WHATLEY-STUART SUBDIVISION

APPLICATION NUMBER 10 DATE July 9, 2015

REQUEST Subdivision

SITE PLAN

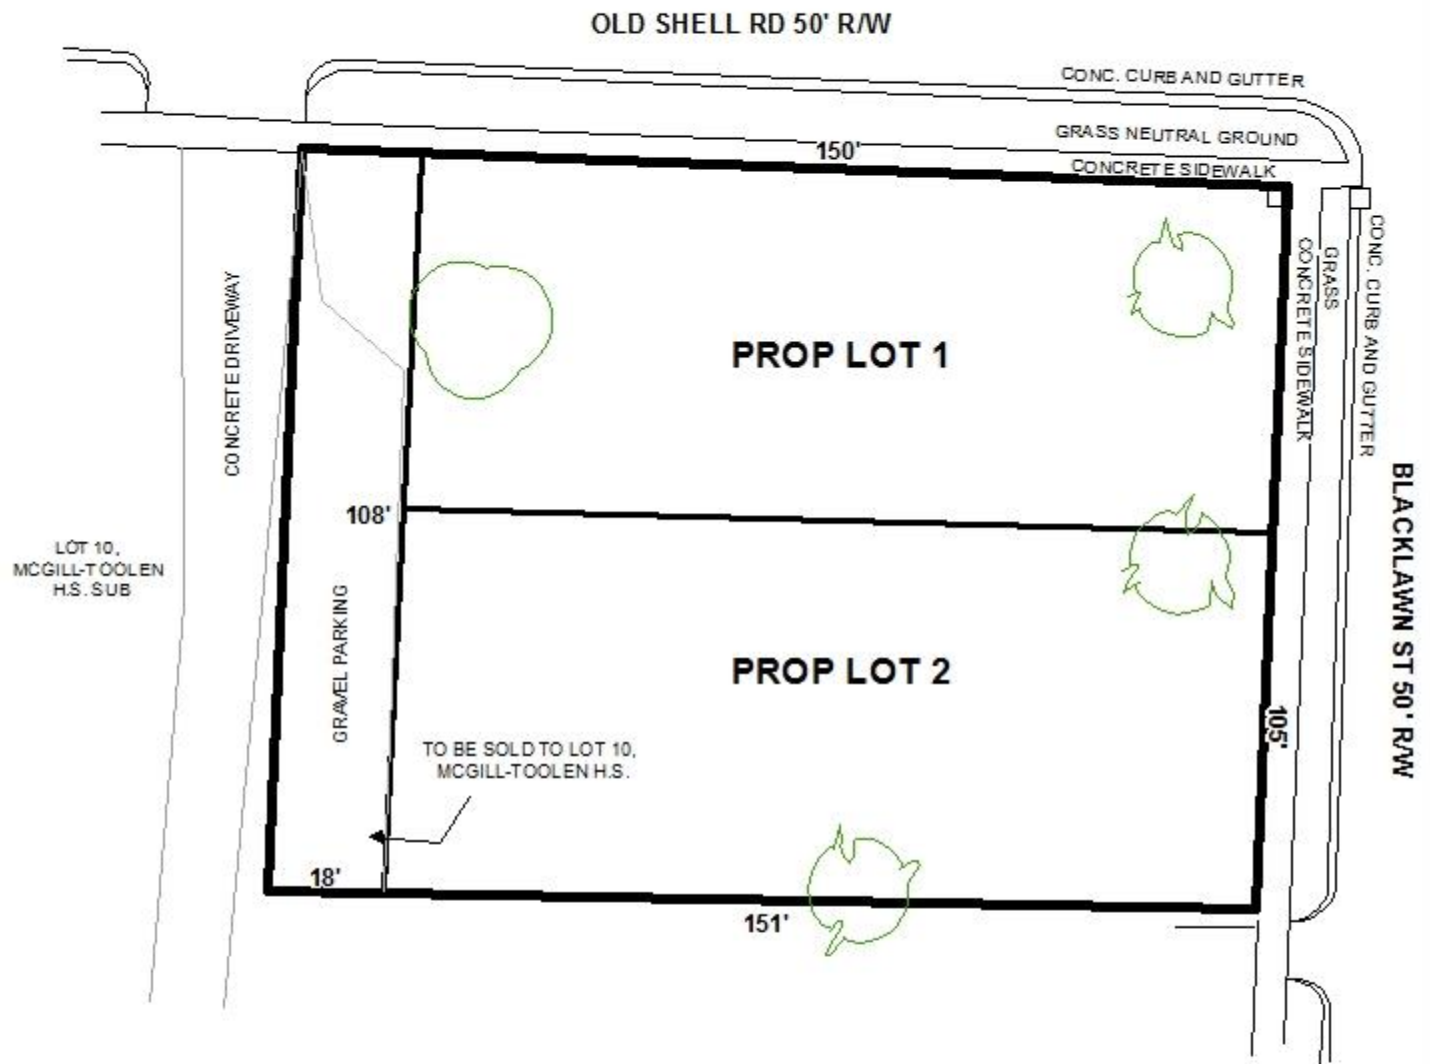
The plat illustrates the proposed 2-lot, 0.4± acre subdivision, which is located at the Southwest corner of Old Shell Road and Blacklawn Street, in Council District 2. The applicant states the site is served by city water and sewer services.

As proposed, Lot 1 would contain 6,732 square feet, less than the 7,200 required by Section V.D.2. of the Subdivision Regulations. And both lots would be less than the minimum 60' width at the building setback line required as per that section. However, as there are other substandard size lots both within the Blacklawn's Subdivision and within the immediate vicinity across Old Shell Road, a waiver of that section would seem in order.

The site fronts Old Shell Road and Blacklawn Street, both minor streets with complaint 50' rights-of-way; therefore, no dedication would be required. However, the plat should be revised to provide a 25' radius curve at the intersection of Old Shell Road and Blacklawn Street, if determined to be necessary by Traffic Engineering or Engineering. As a means of access management, each lot should be limited to one curb, with the size, design and location to be approved by Traffic Engineering and conform to AASHTO standards.

Each lot should be labeled with its size in square feet and acres, with the size of Lot 1 revised for any required dedication, or a table should be furnished on the Final Plat providing the same information.

The plat indicates a proposed 25' building setback along Old Shell Road and Blacklawn Street, and 5' setbacks along internal lot lines. An 8' rear setback is proposed. However, as the site is within the Old Dauphin Way Historic District, a note should be required on the Final Plat stating that all setbacks would be subject to the Historic District Overlay of the Zoning Ordinance if standard setbacks are not applied. A note should also be required on the Final Plat stating that each lot is limited to a maximum of 50% site coverage by all structures.

With a waiver of Section V.D.2., the plat meets the minimum requirements of the Subdivision Regulations and is recommended for Tentative Approval, subject to the following conditions:

- 3) dedication to provide a 25' radius curve at the intersection of Old Shell Road and Blacklawn Street, if determined to be necessary by Traffic Engineering or Engineering;

- 4) placement of a note on the Final Plat stating that each lot is limited to one curb cut, with the size, design and location to be approved by Traffic Engineering and conform to AASHTO standards;

- 5) labeling of each lot with its size in square feet and acres, with the size of Lot 1 revised for any required dedication, or the furnishing of a table on the Final Plat providing the same information;

- 6) placement of a note on the Final Plat stating that all setbacks would be subject to the Historic District Overlay of the Zoning Ordinance if standard setbacks are not applied;

- 7) placement of a note on the Final Plat stating that each lot is limited to a maximum of 50% site coverage by all structures;
- 8) subject to the Engineering comments: *[The following comments should be addressed prior to submitting the FINAL PLAT for acceptance and signature by the City Engineer:*
